From: James Cox
Sent: 27 November 2018 16:26
To: Rob Smith
Cc: 'Robert Staniland'
Subject: RE: LNG proposals s96a initial clarifications [NLP-DMS.FID262297]

LNG proposals – initial clarifications (s96a application - NYM/2018/0662/nm)

Woodsmith Mine
Section 96a
LNG / Generator Plant
Sections

Woodsmith Mine
Section 96a
LNG / Generator Plant
Compound

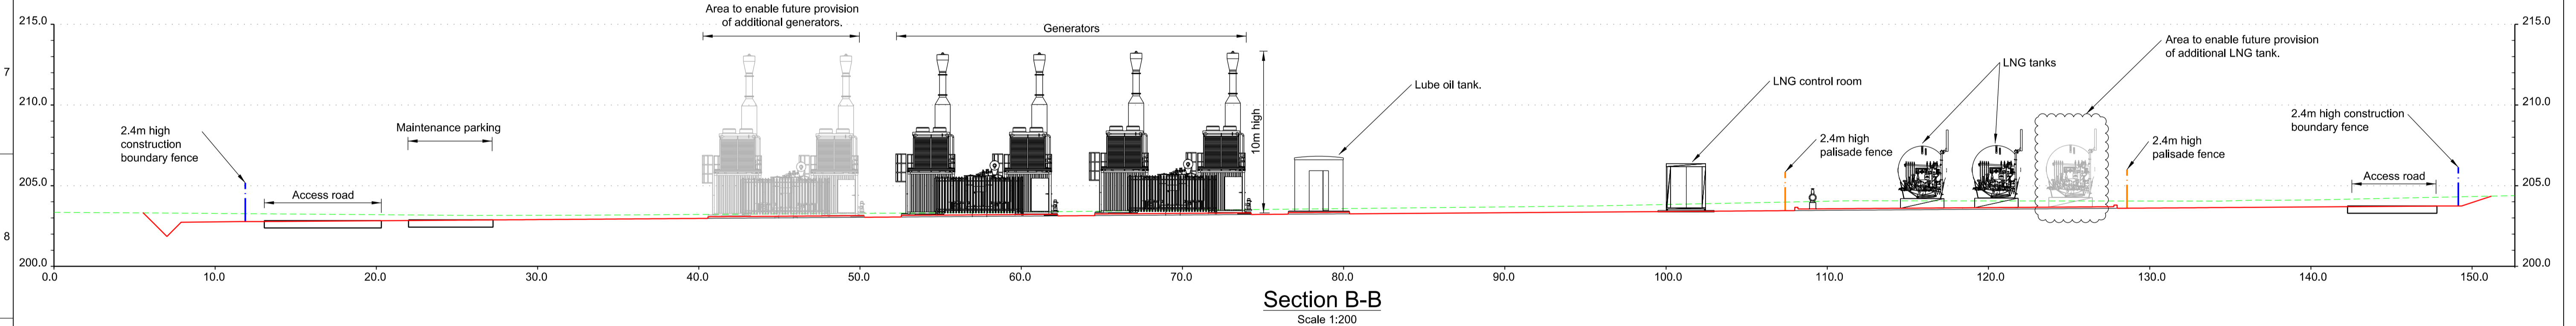
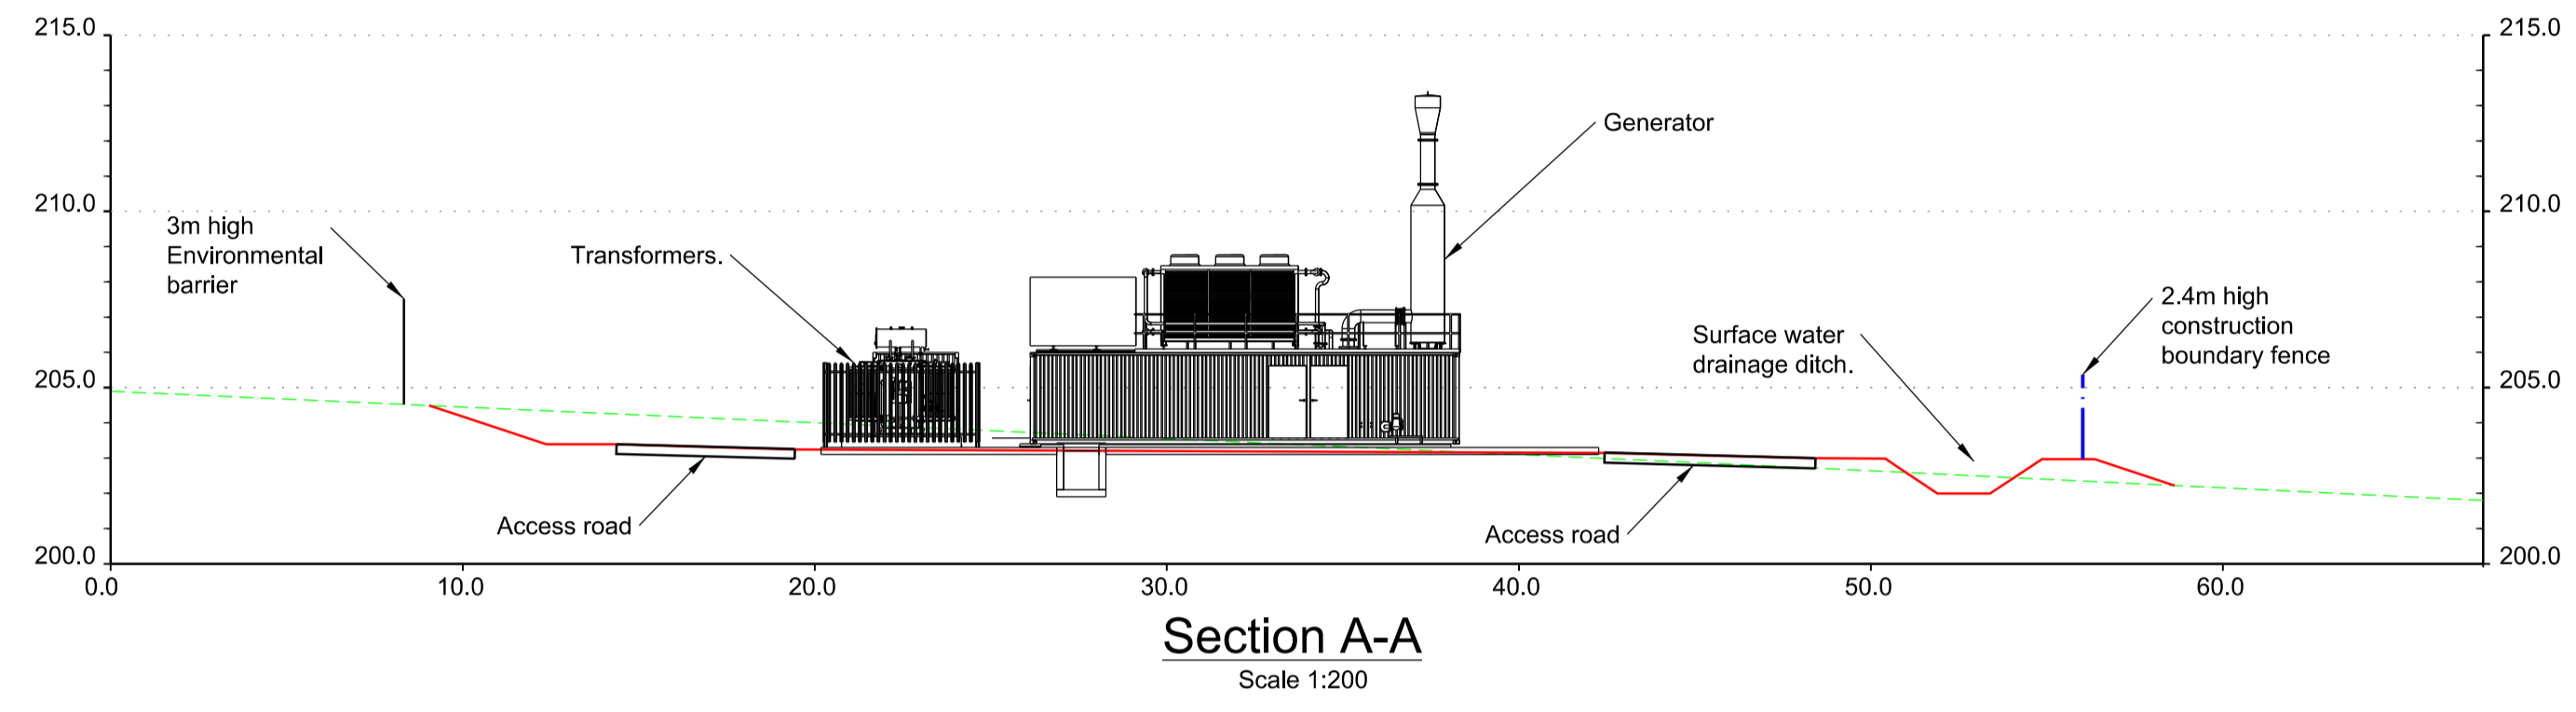
- LNG / Generator Plant Compound Layout Plan (ref. 40-ARI-WS-7100-CI-18-01026); and
- LNG / Generator Plant Sections (ref. 40-ARI-WS-7100-CI-10-01027)

- i. A revised lighting scheme;
- ii. The removal of fire water and foam storage tanks; and
- iii. The introduction of a 3m timber screening fence at the south-western boundary of the site.

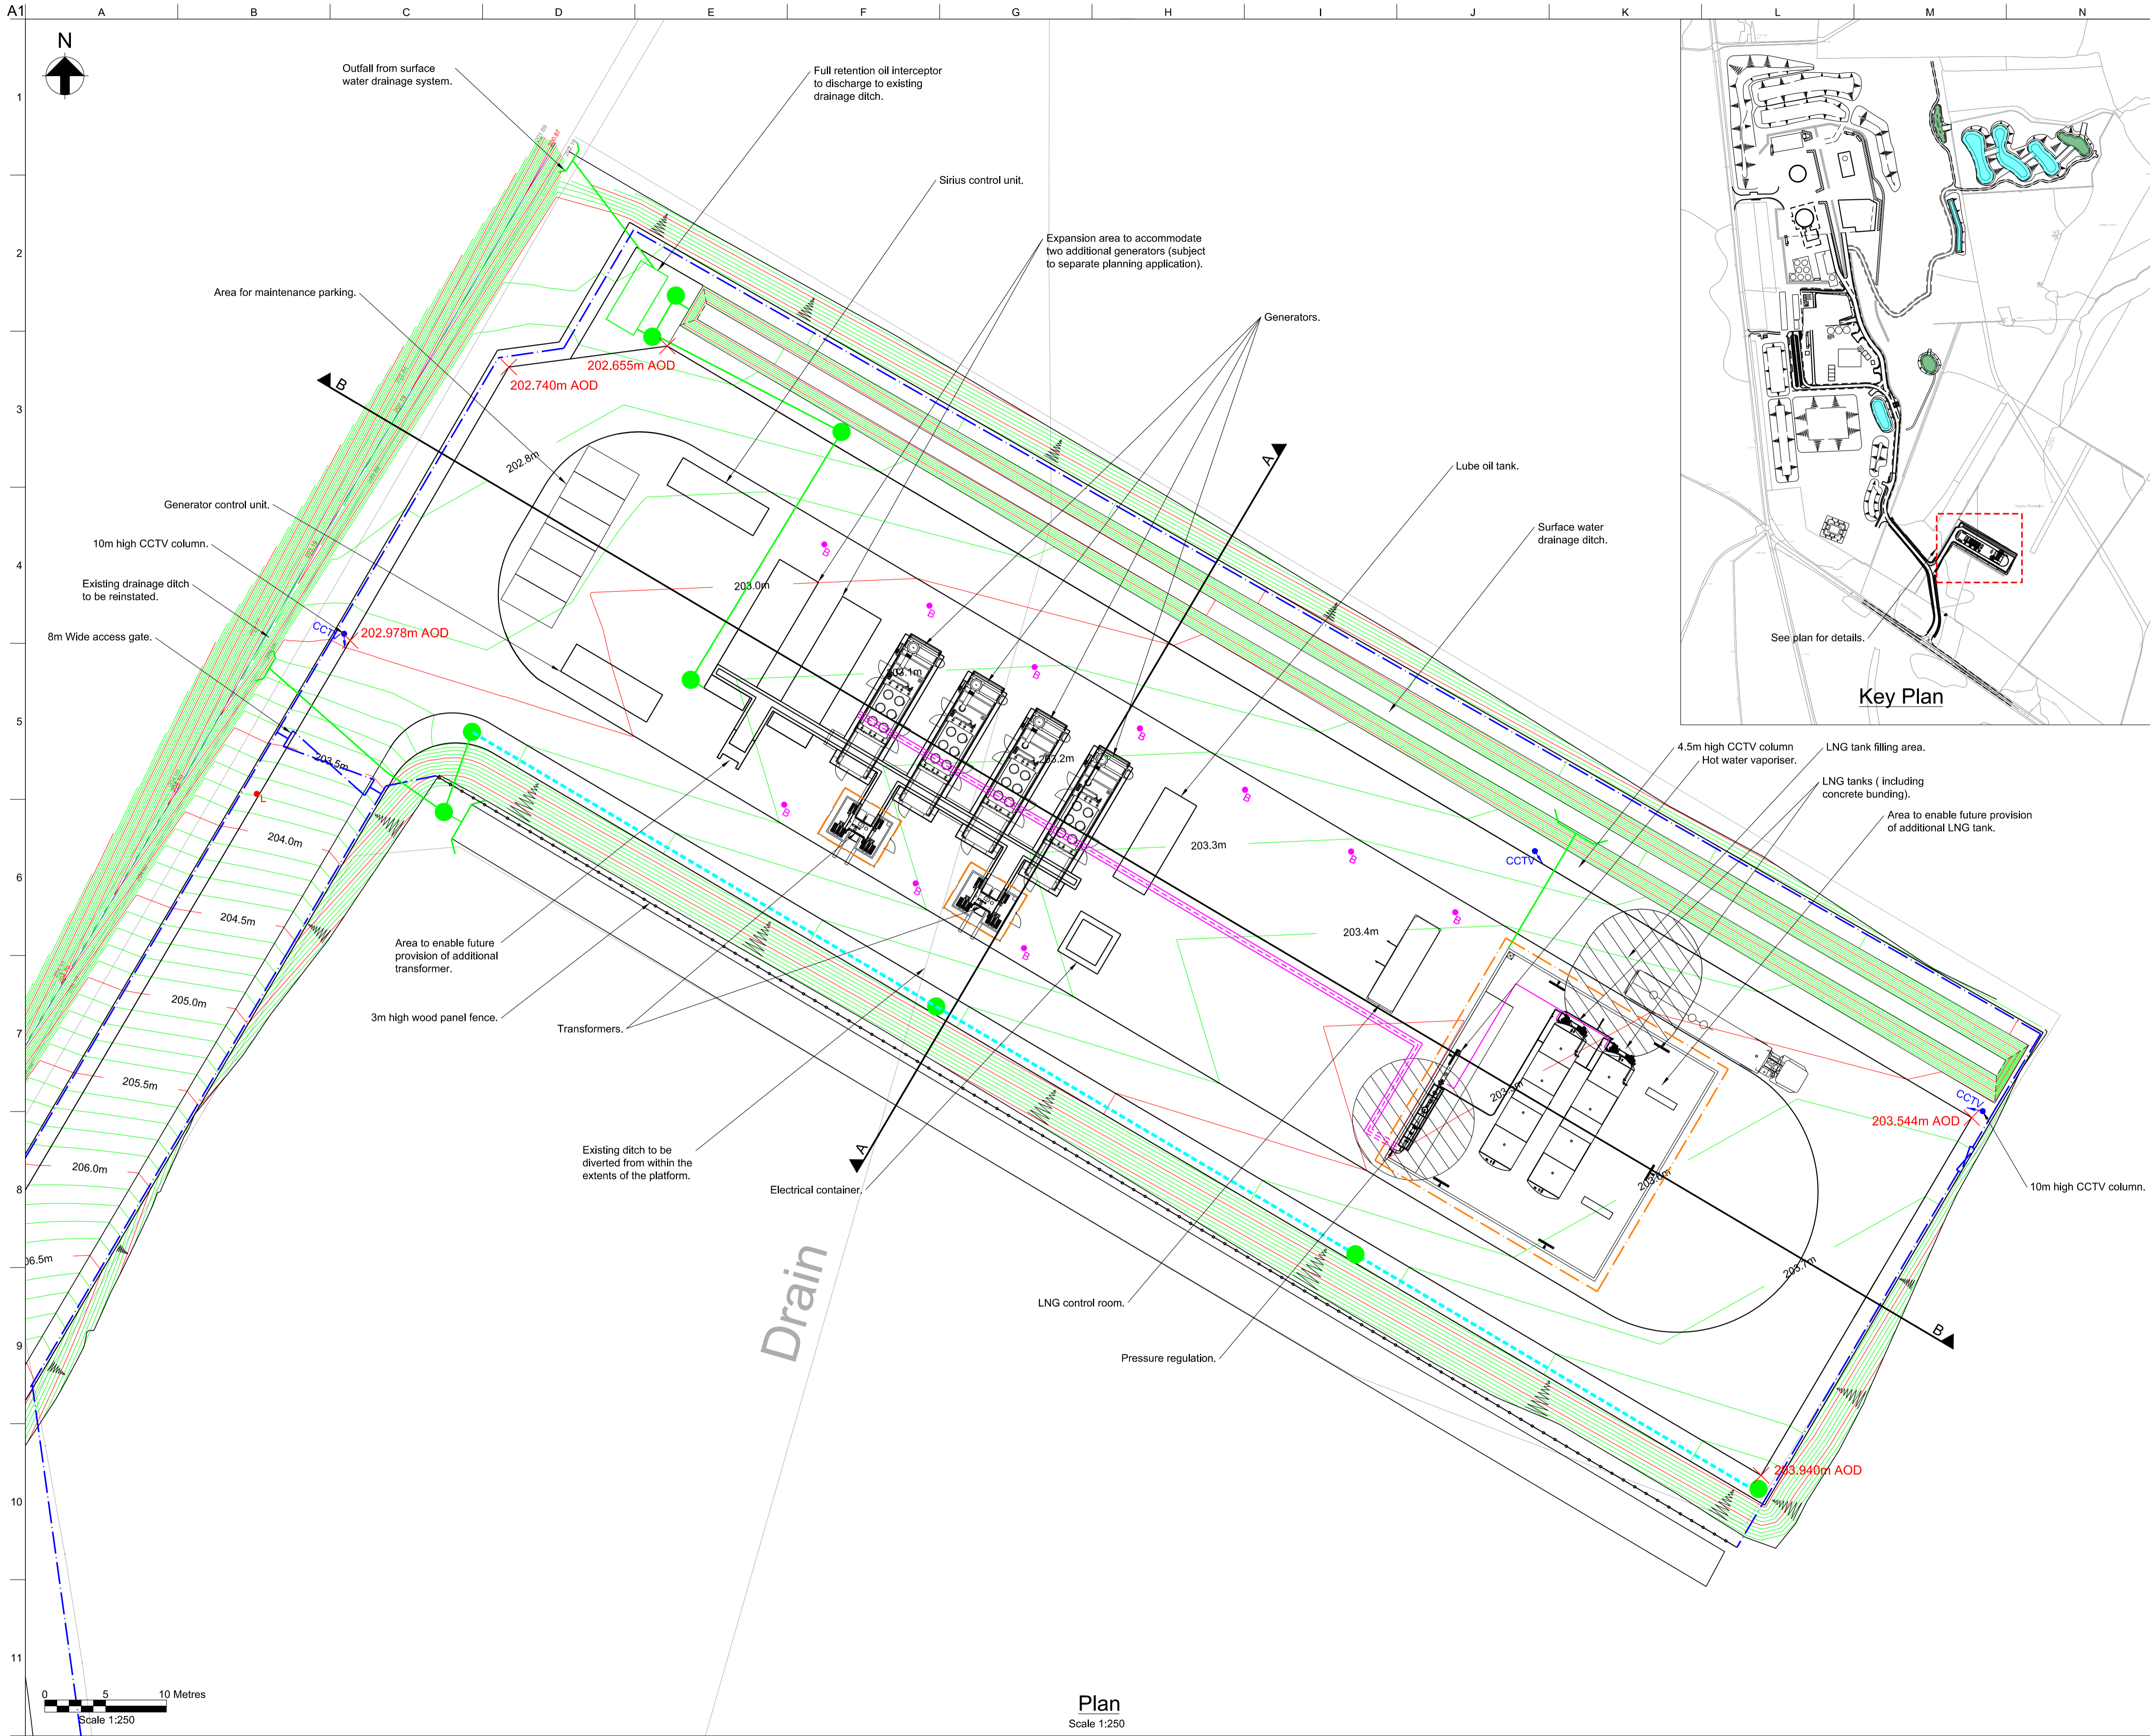
- It is assumed that the access road to the LNG compound and the internal access route and parking areas within the compound itself will be provided with a bituminous surface, however this is not specifically shown on the drawings. Please could this be clarified. [This is confirmed.](#)

- Please clarify what surfacing is proposed for other elements of the LNG compound (ie areas not specifically intended for use by vehicles)? [The container bases will be concrete and the areas between the roads will be surfaced in bitmac.](#)

- The layout drawing for the LNG compound shows provision of two lighting columns adjacent to the NE corners of the LNG tanks filling area. There may be potential for light from these to be directed towards the main site entrance area, where existing tree and shrub vegetation is at its thinnest (as noted on the site visit held on 25 October 2018). Is there potential for these columns to be re-located/re-orientated to reduce the potential for this? [The lighting scheme for the LNG facility has been redesigned in response to these comments and now incorporates lower-level bollard lighting, akin to that which has been installed at the Cross Butts P&R facility. This is reflected on a revised site layout plan \(ref. 40-ARI-WS-7100-CI-18-01026 rev. 2\). All higher level lighting, including that around the LNG compound, will be orientated into the site so as to avoid light spill. Lighting will also only be used when it is necessary \(see below\).](#)

- Is the red 'dot' shown on the drawing (but not accompanied by a corresponding 'L' symbol, as used to indicate proposed lighting columns on the drawing), located near the point where the access road enters the main compound, intended to represent a lighting column. If not what does this symbol represent? [This is confirmed and has been clarified on the revised layout drawing. The light will be operated via a control switch at the entrance gate and used on a timer so as to ensure that it is on no longer than necessary.](#)

- It is noted that two 10m high CCTV columns are proposed, together with a smaller column. Is any visible lighting proposed in direct association with these CCTV columns? What is the proposed finish of the columns? [No direct lighting is proposed by virtue of the CCTV system being infrared. The columns will have a power coated steel RAL6008 finish.](#)
